工程指示 / 要求簡箋 ENGINEER INSTRUCTIONS(E.I.)

工程指示編號:	EI- 6438 / 23	修改版本:	-
	HK- 14PR / 23		
工程編號:	J 857	工程名稱:	啟德6552
收件人:	生統	發件人:	nero
工程項目:	後裝百葉 - 廠用加工圖(AL55)	日期:	05/07/2023

Project Proposed Residential Development at N.K.I.L. No. 6552, Kai Tak Area 4C, Site 2, Kai Tak, Kowloon

Subject **Confirmation of Omission for AL56 at 1/F and Revised Aluminium Louvre Size for AL55 at 1/F Owner's Committee Office**

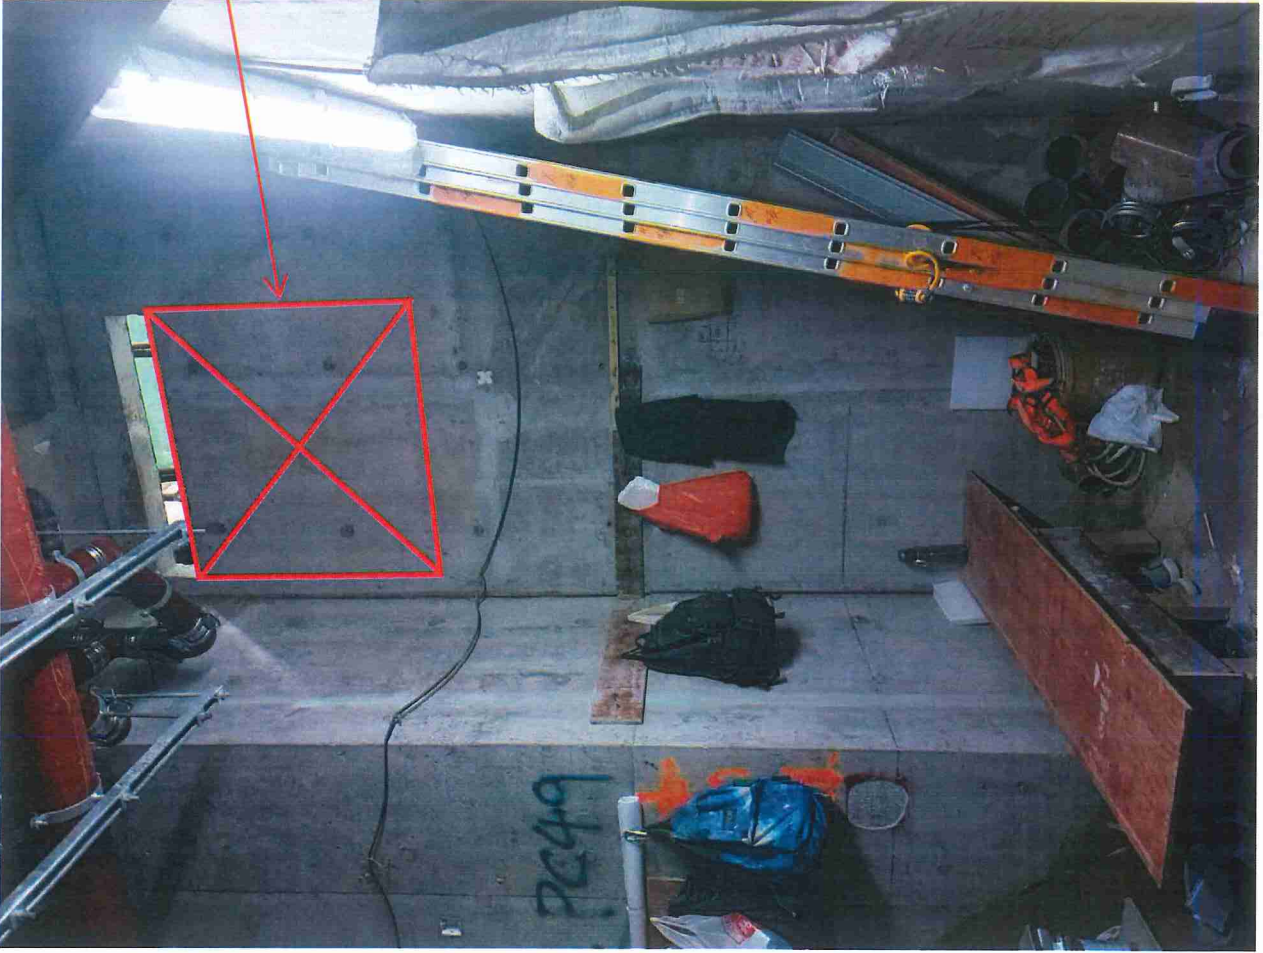
Descriptions Further to discussion with PM and RLP at coordination meeting on 21.06.2023, we would like to confirm that AL56 at 1/F will be omitted and louvre size for AL55 will be revised at 1/F owner's committee office as per attached sketches for our construction. The routing of lift vent duct will be confirmed separately.

Please note that abortive works shall be incurred subject to concrete hack-off to existing RC wall and abortive materials on louvre AL55 and AL56.

concrete hack-off to RC wall
for louvre installation (AL55)

E05 ELEVATION (FACING T6)
 SCALE 1 : 50

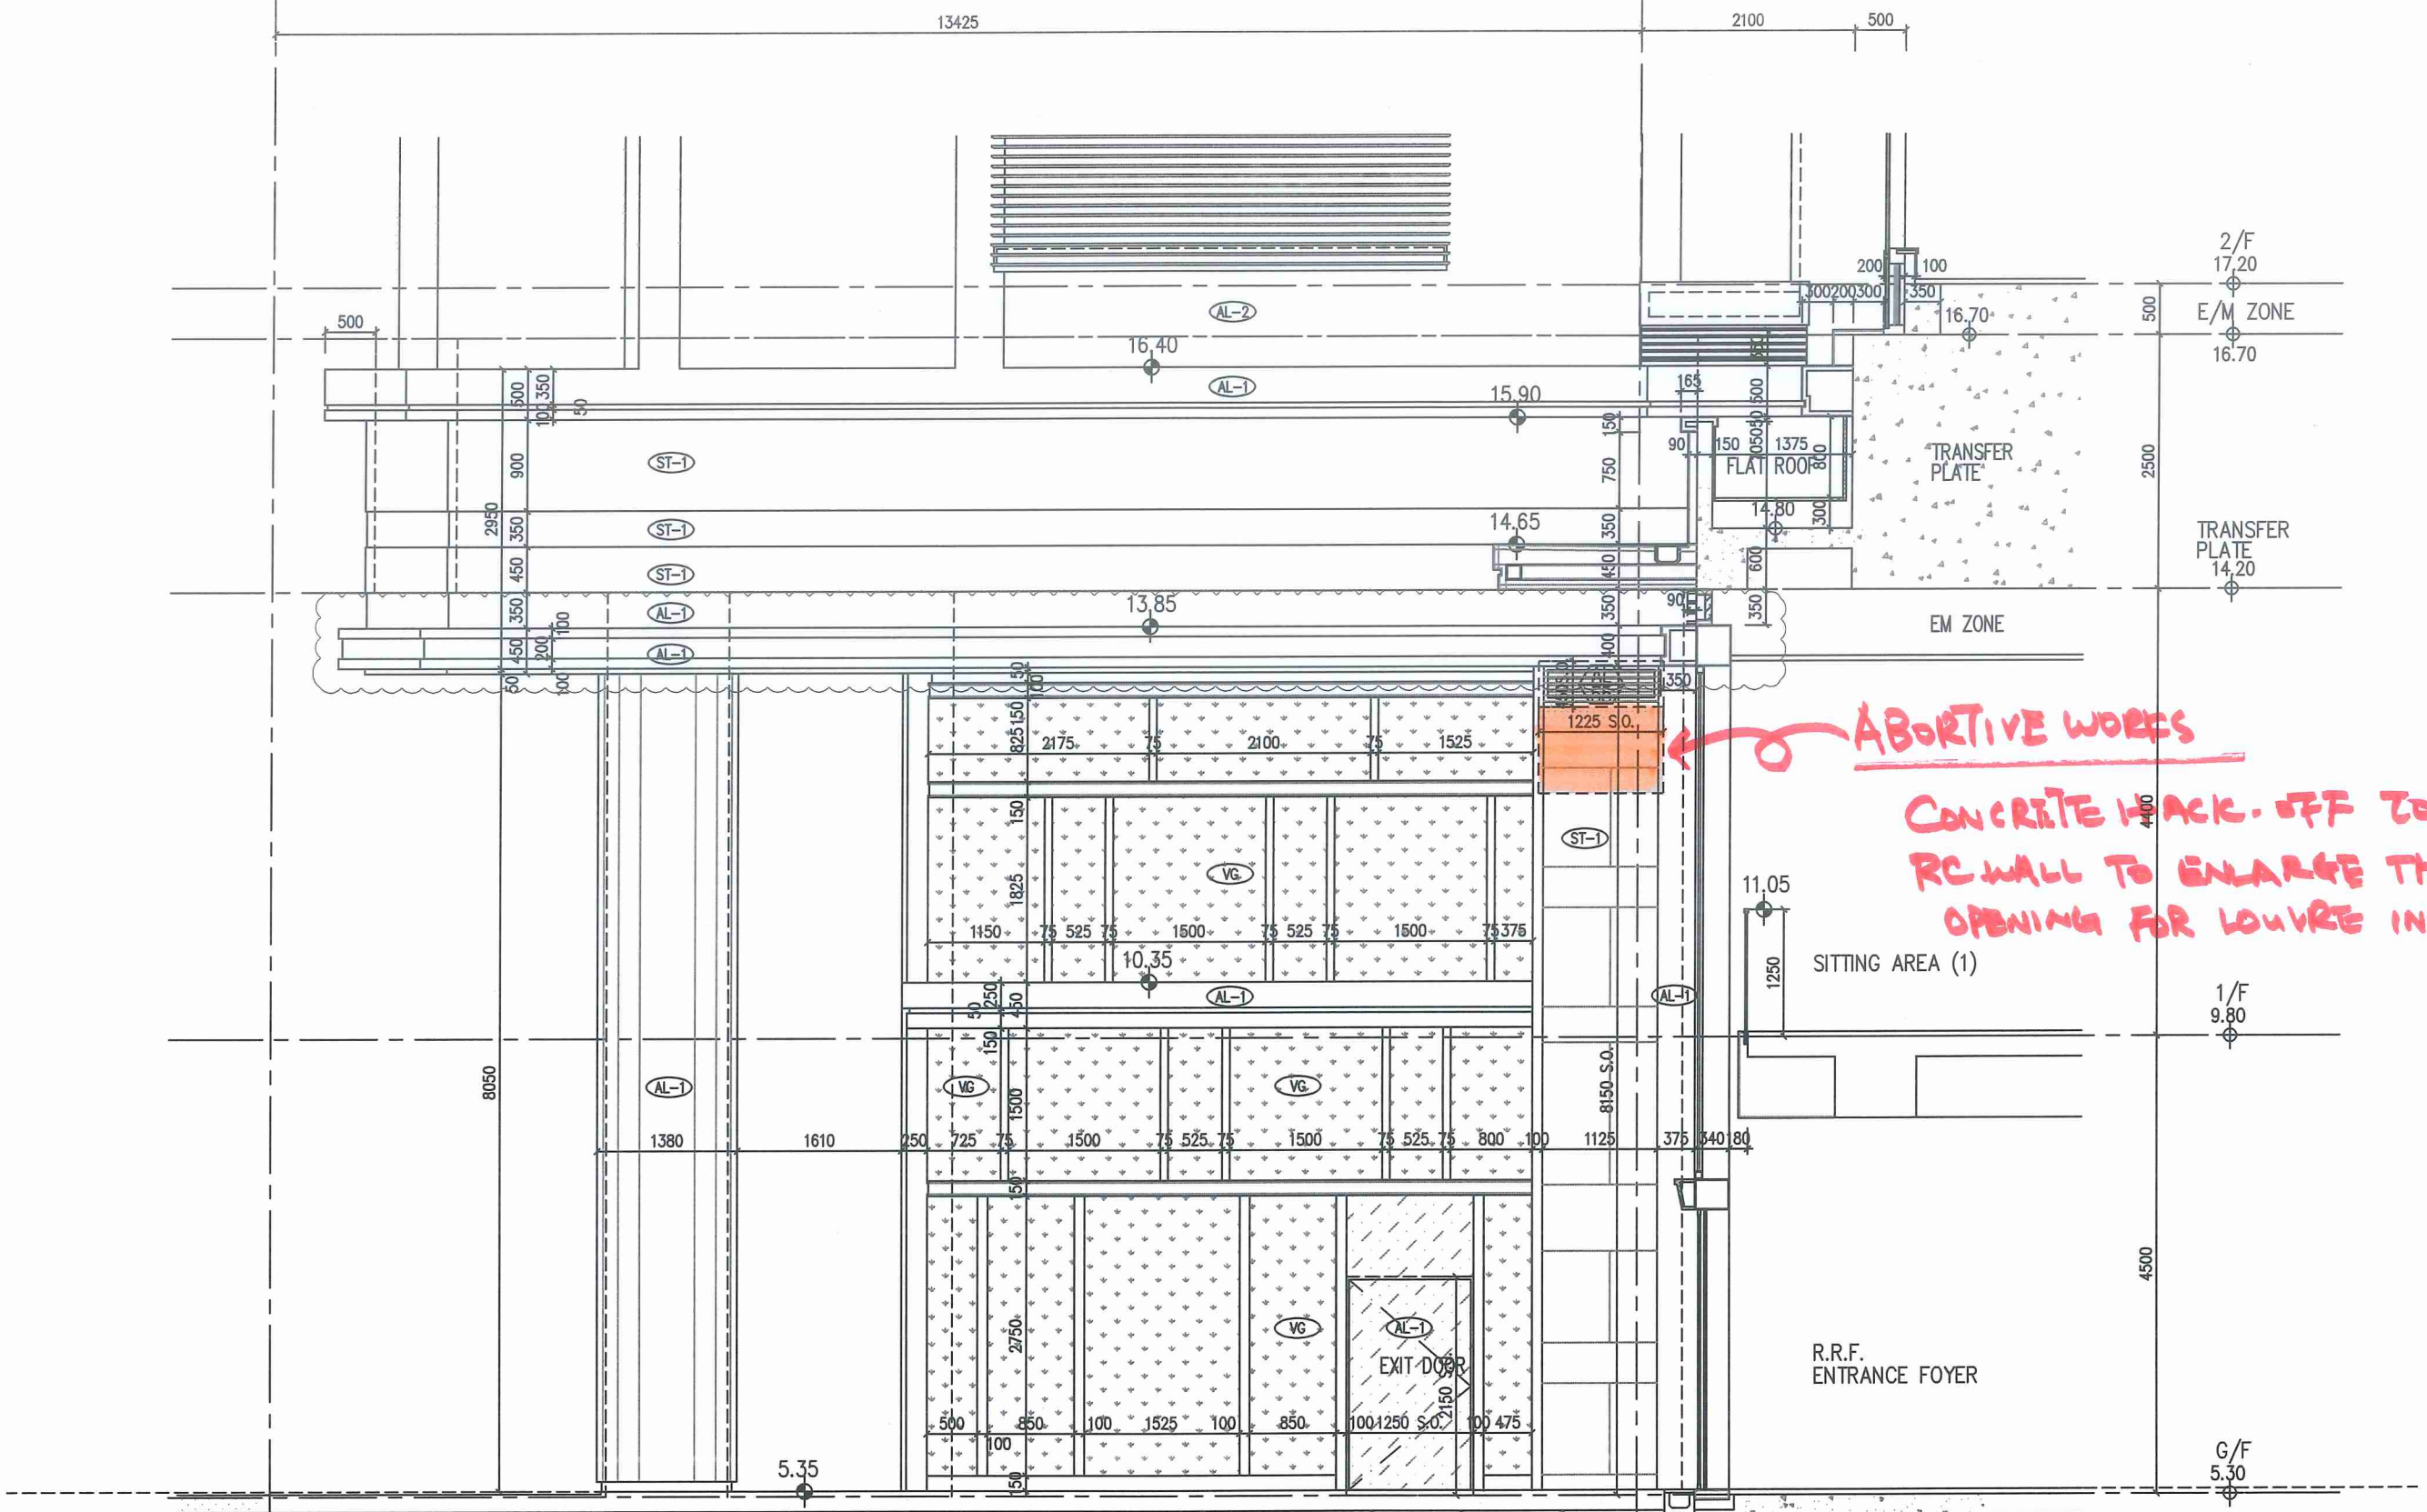
ABORTIVE WORKS
CONCRETE HACK-OFF TO RC WALL TO ENLARGE THE OPENING FOR LOUVRE INSTALLATION
